ERRATUM

PREPARING THE BOILER FOR GAS CONVERSION & WATER TREATMENT GRAPH

Nesta 300 manual - A-136280 rev.A - EN - page I-32 and I-43.

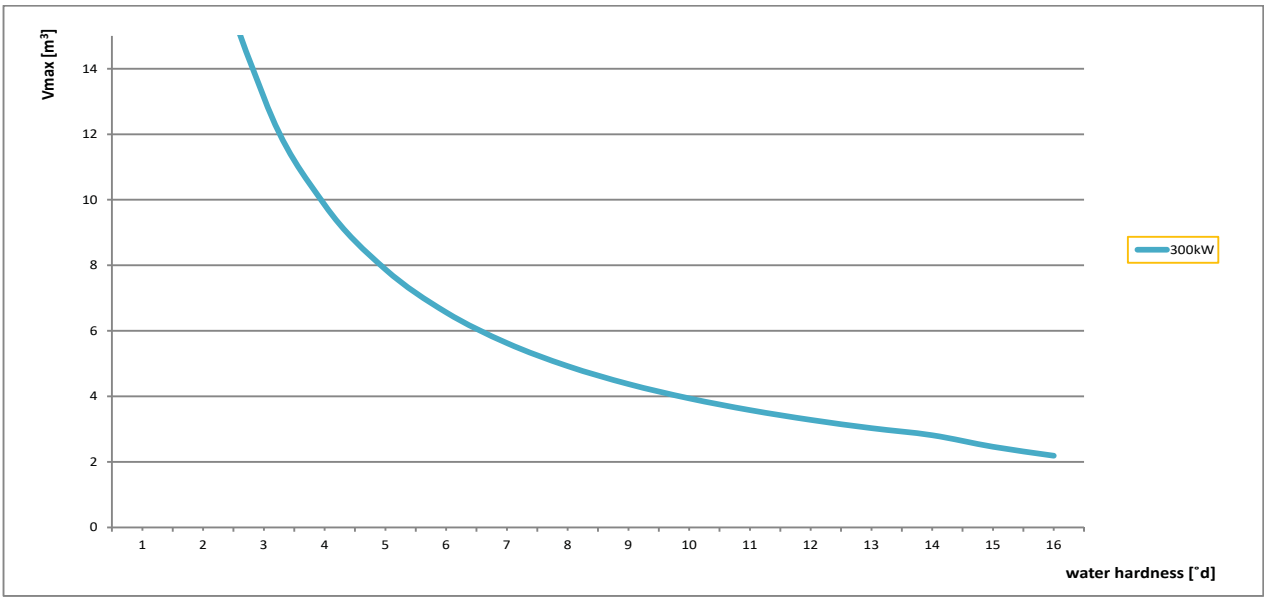
1. Addition of the water treatment graph in water parameters section.
